Serial No. 10/597,906  
Filed: May 8, 2007  
Page 8 of 15

**Amendments to the Drawings**

### **REMARKS**

Figure 2

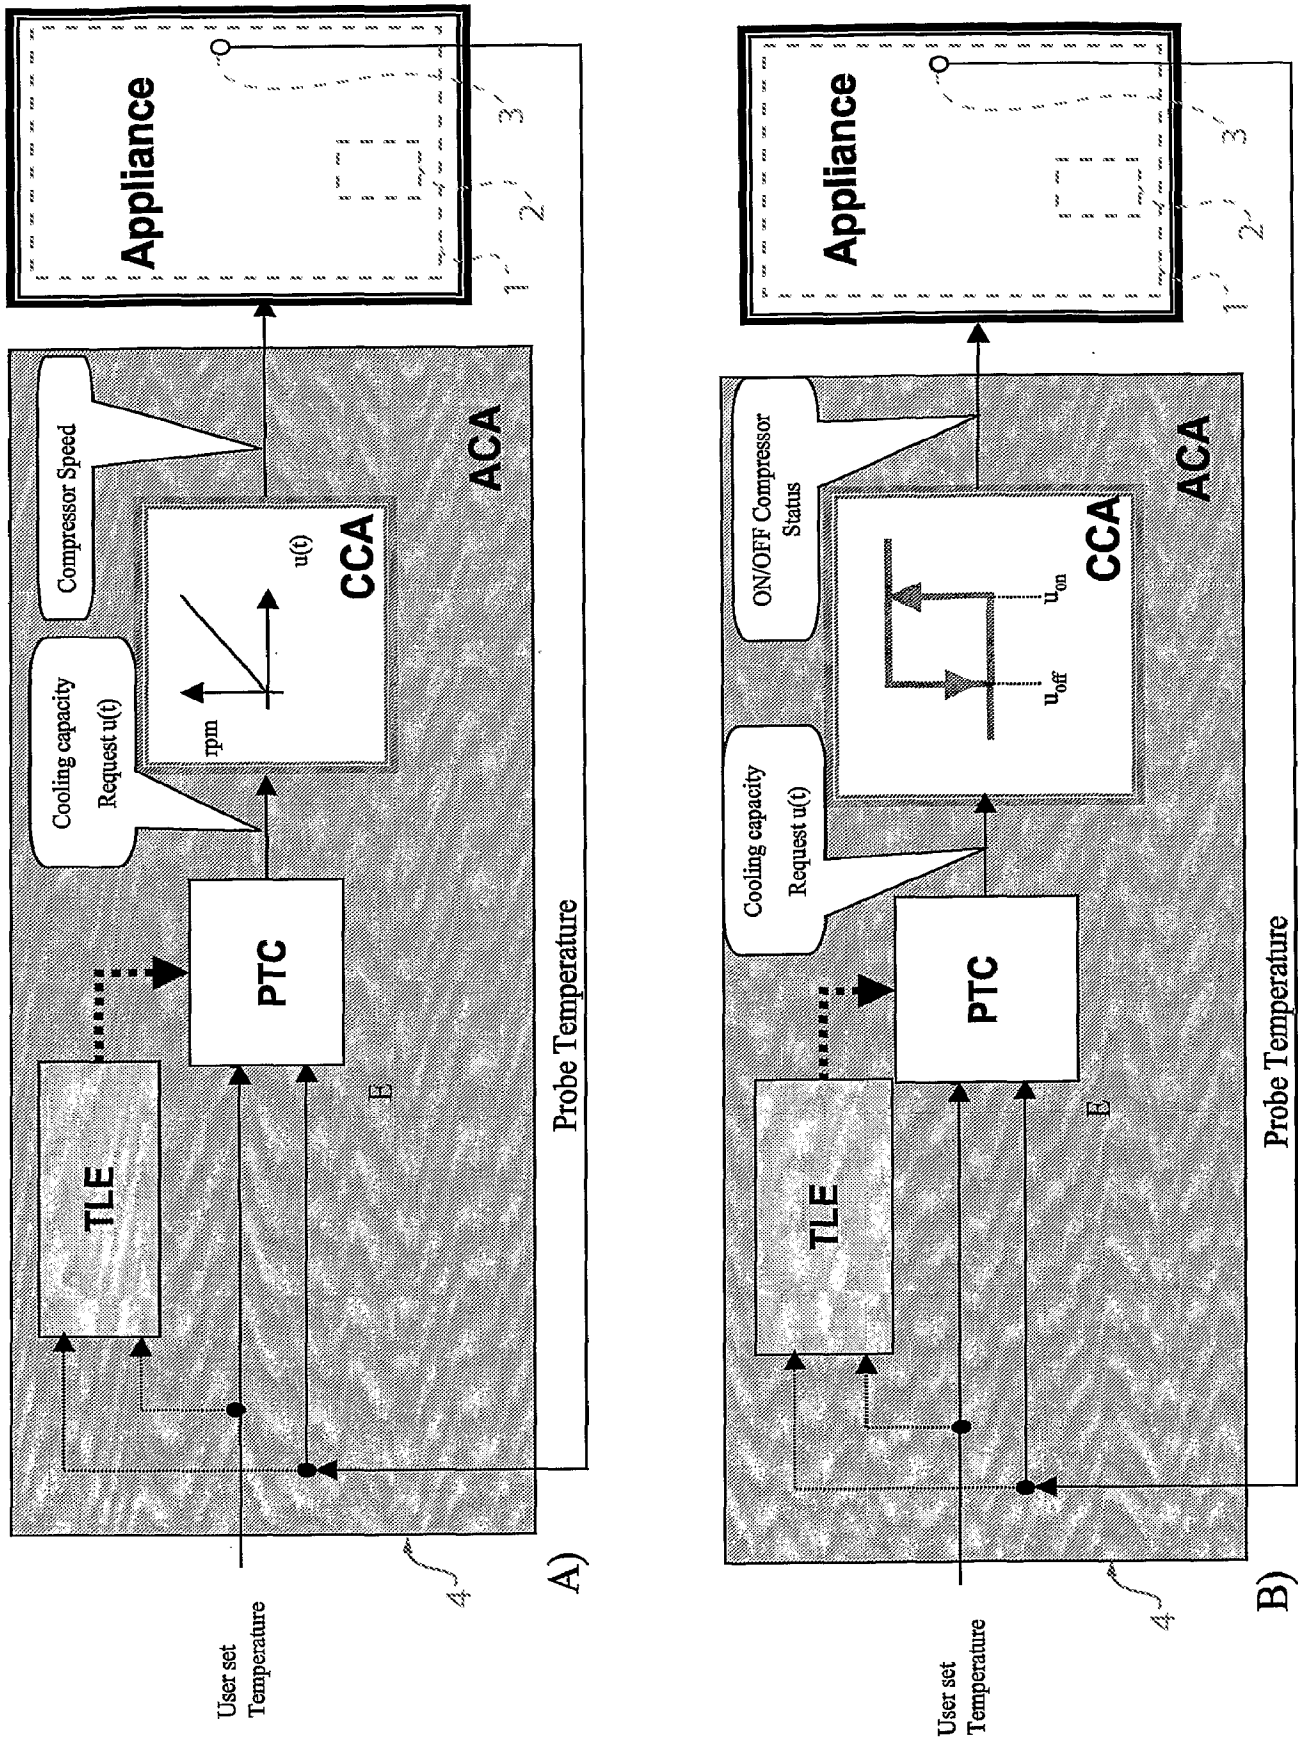
The drawings are objected to under 37 CFR 1.83(a) for failure to show the “cooling chamber”, “compressor”, “temperature sensor”, and “controller” of the claims. Applicants have amended Figures 2A and 2B to show numeric representation for the cooling chamber, compressor, temperature sensor, and controller. Applicants believe this amendment to be fully supported by the claims and the application as filed, and respectfully request withdrawal of the objection.

Kindly replace the original drawing sheet containing Figures 2A and 2B with the attached Replacement Sheet containing amended Figures 2A and 2B. An Annotated Sheet with a marked-up version of Figures 2A and 2B is provided to assist the Examiner in readily identifying the amendments made to Figures 2A and 2B. In particular, numeric representation of the cooling chamber, compressor, temperature sensor, and controller has been added to the figures to support the features of the invention specified in the claims.

Figures 2A and 2B of the drawings have been amended to include numeric representation of the cooling chamber, compressor, temperature sensor, and controller. Support for this amendment can be found throughout the substitute specification.
